ADDENDUM NO. 1 TO ALL BIDDERS:

Reference – Invitation for Bid:	IFB #015-0-2025/SNB Yates Elementary School Security Vestibule and Office Addition & Alterations
For Delivery To:	Newport News Public Schools
Bids Due:	March 27, 2025 at 2:00 PM EST

## ADDENDUM NO. 1

#### Yates Elementary School Security Vestibule and Office Addition & Alterations

**A1.01**

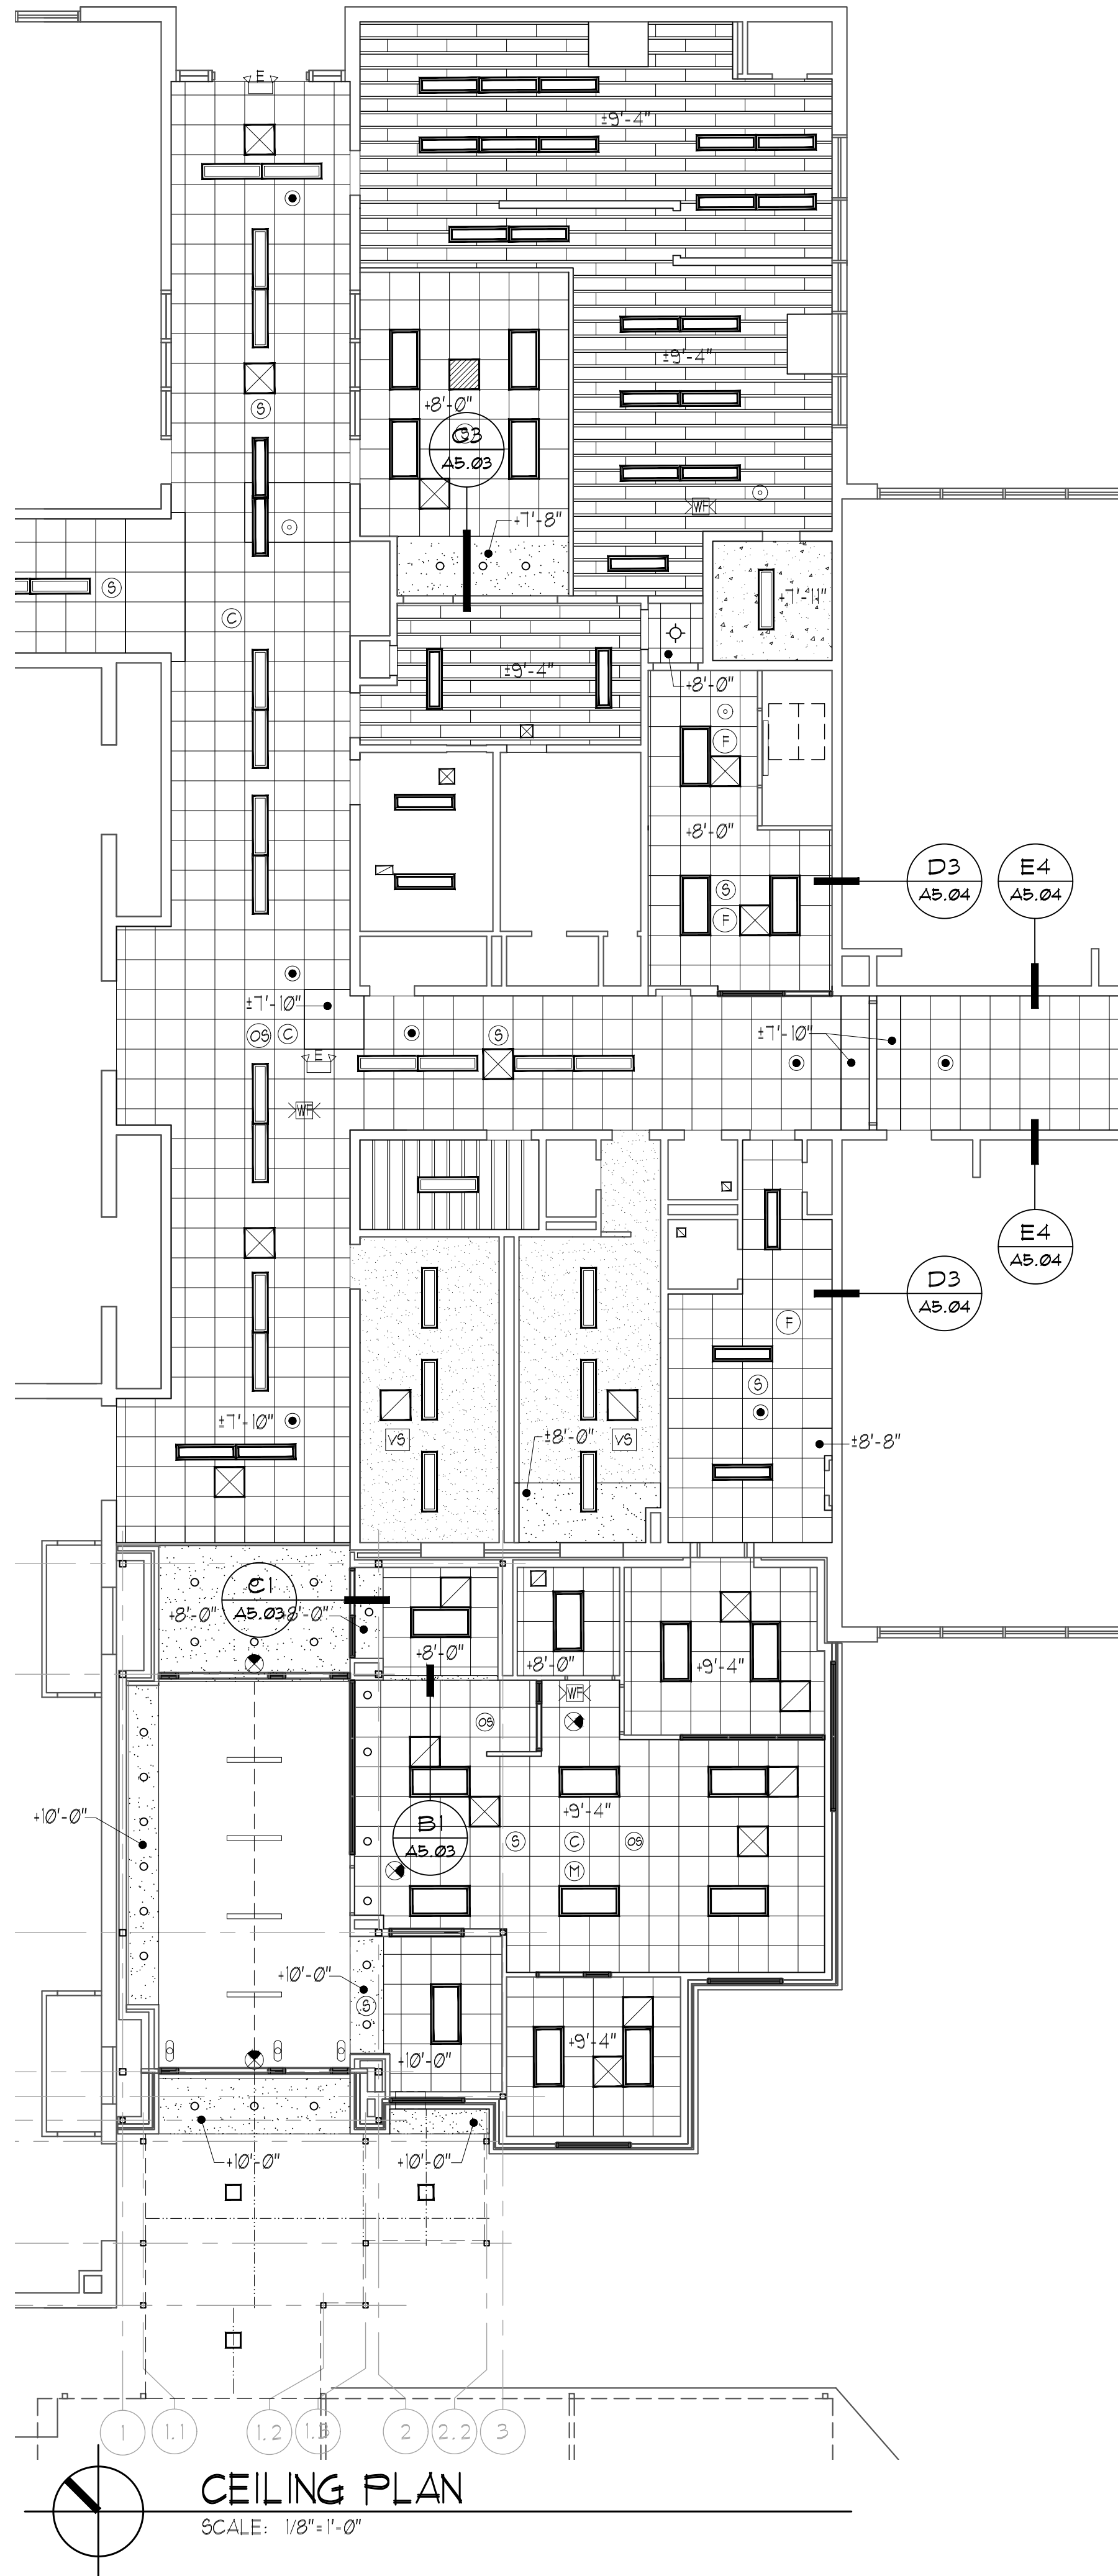
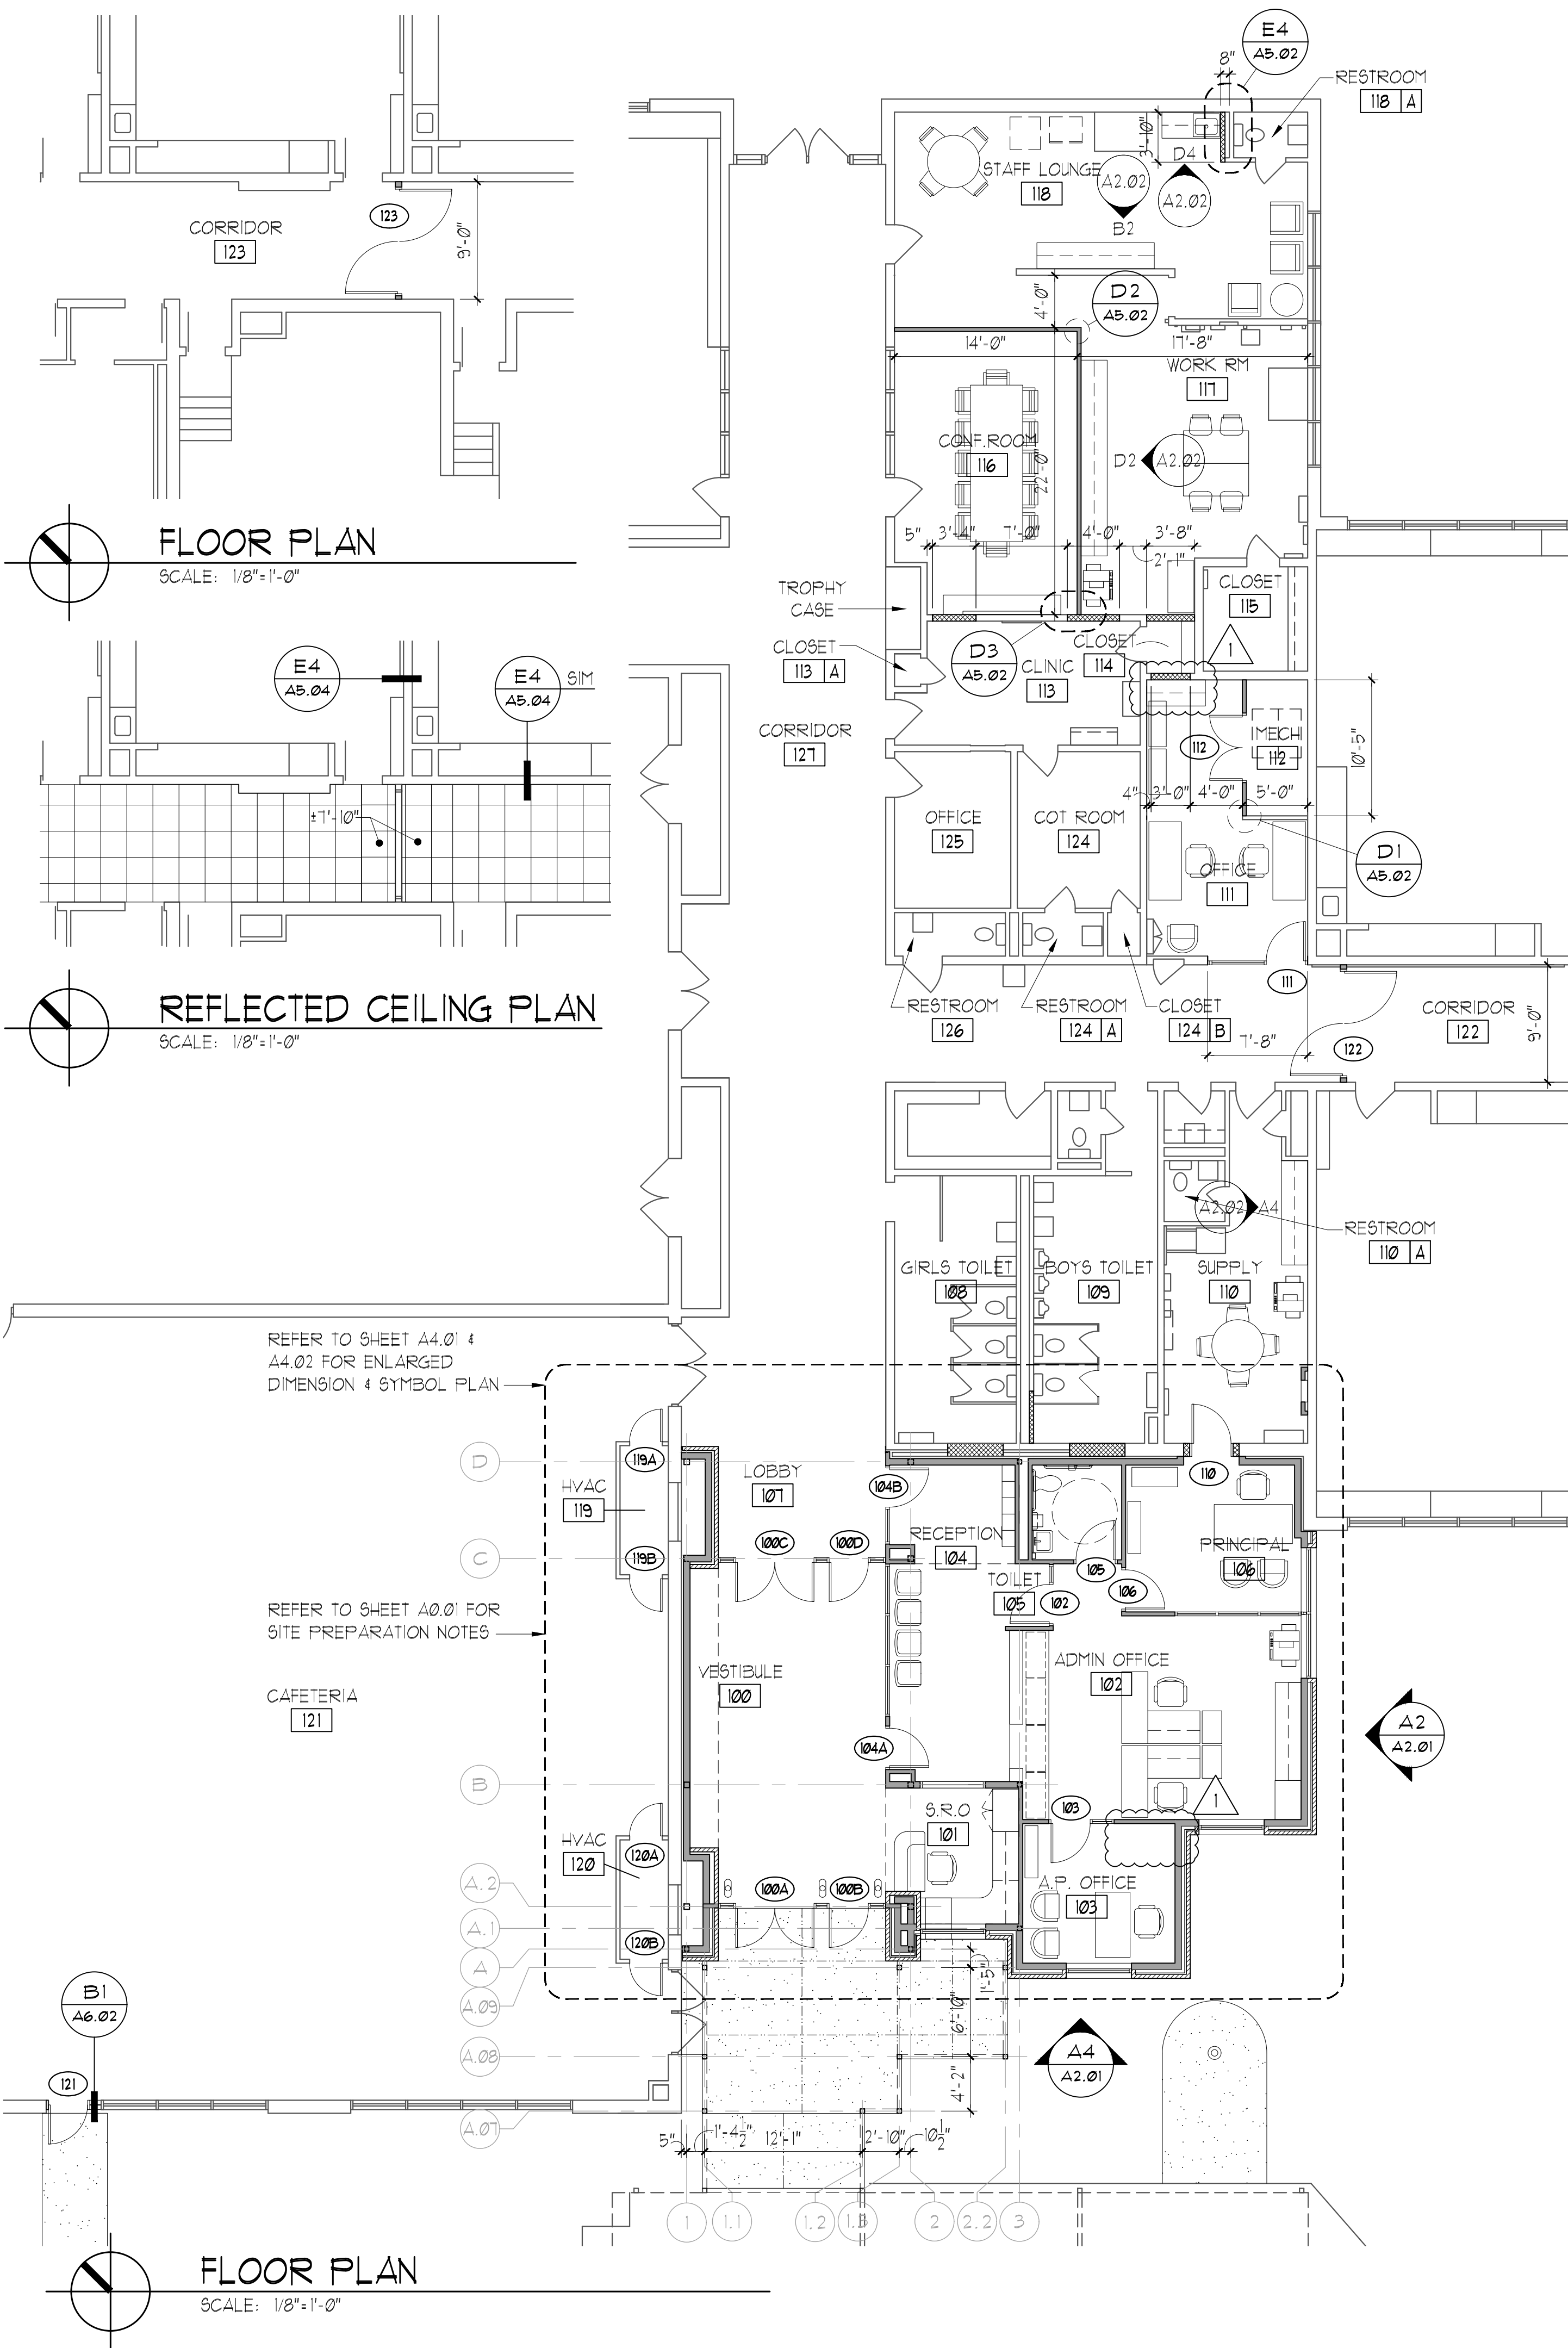
6. Architectural Drawing A1.01: This drawing has been revised to include:
  - a) Omission of casework shown in Assistant Principal's Office, Room 103.
  - b) Relocation of the aforesaid omitted casework to Office 111.
